**Part 150 Comments to Consultants' Citizen Advisory Committee and Technical Advisory  
Committee Presentation of May 28, 2020  
and Proposal for Modified Equivalent Lateral Spacing Operations (ELSO) Option**

**Anthony M. Stiegler, CAC Member, and Chris McCann, TAC Member  
Quiet Skies San Diego  
Quiet Skies La Jolla  
July 20, 2020**

Fig. 4.

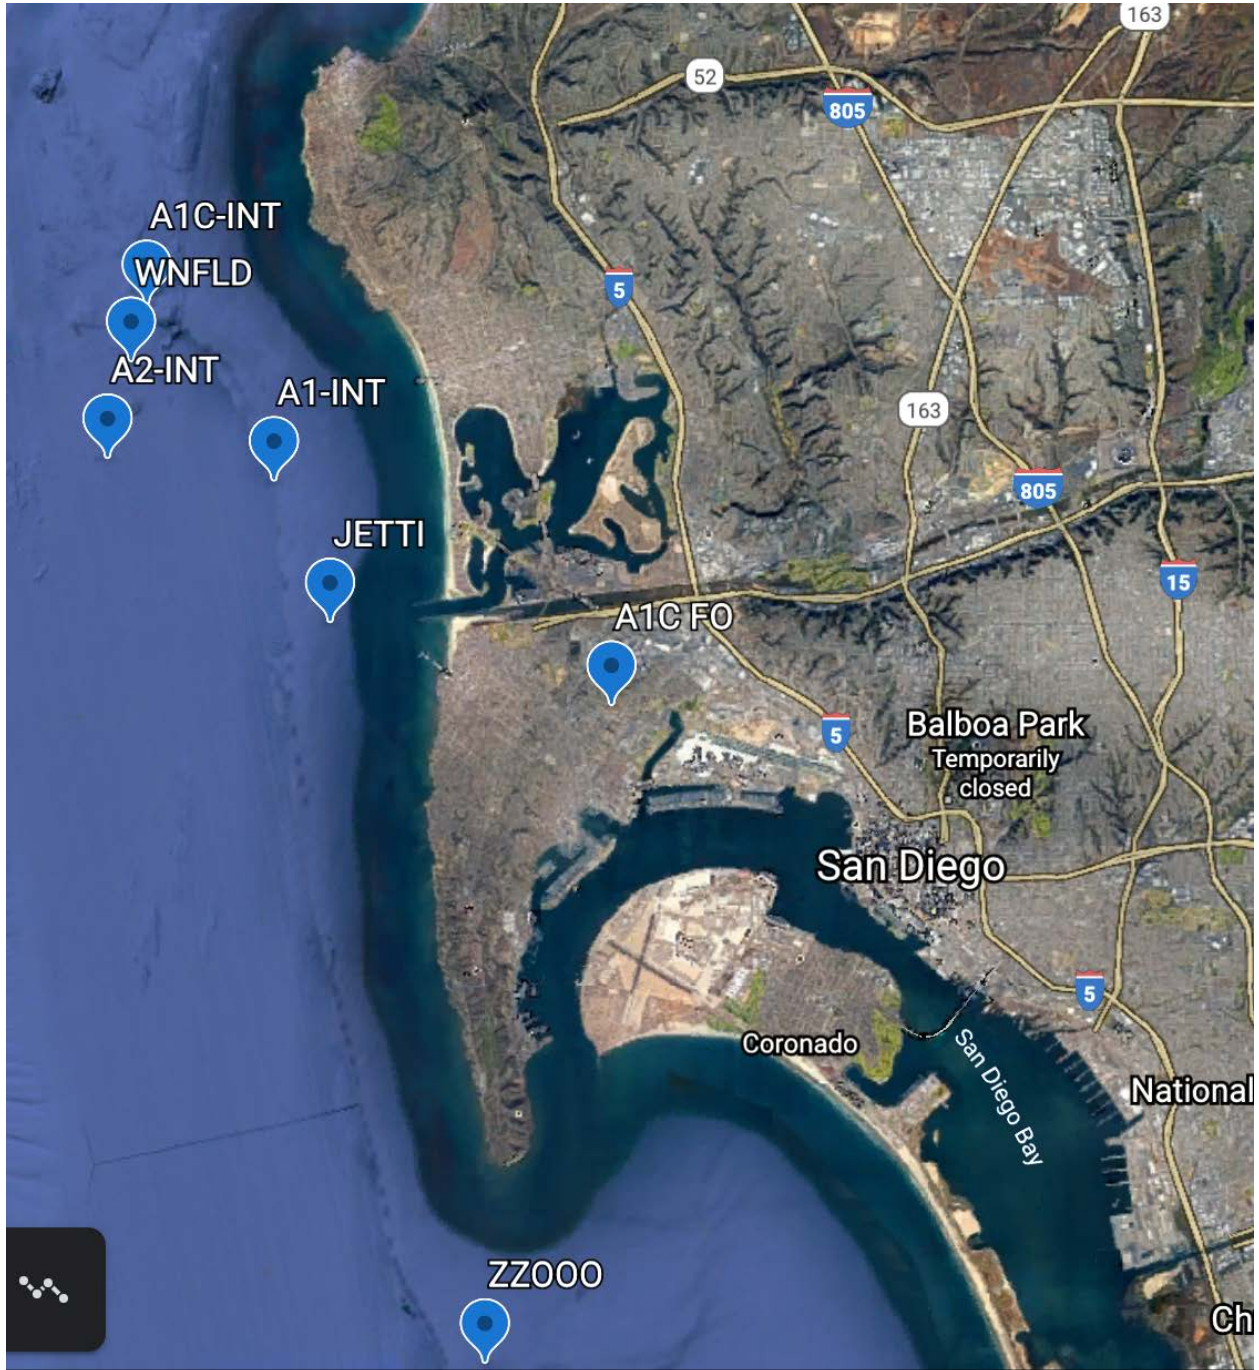
We note the consultants observation that “we can put the waypoints anywhere you want within reason” and we, therefore, would urge the consultants to anchor their designs and modeling on this central principle: use waypoints that are furthest west offshore as possible, measured from the center of the Mission Bay Jetty, routing planes as far away from our coastlines as possible. For clarification purposes, the coordinates for the suggested A2 INT waypoint should be placed as far west of the shoreline, and as far south of the WNFLD waypoint, as possible. The following Fig. 4 was created based on coordinate data provided by

the consultants to a CAC member showing in concept the location of the waypoints as we understand them to be presently conceived:
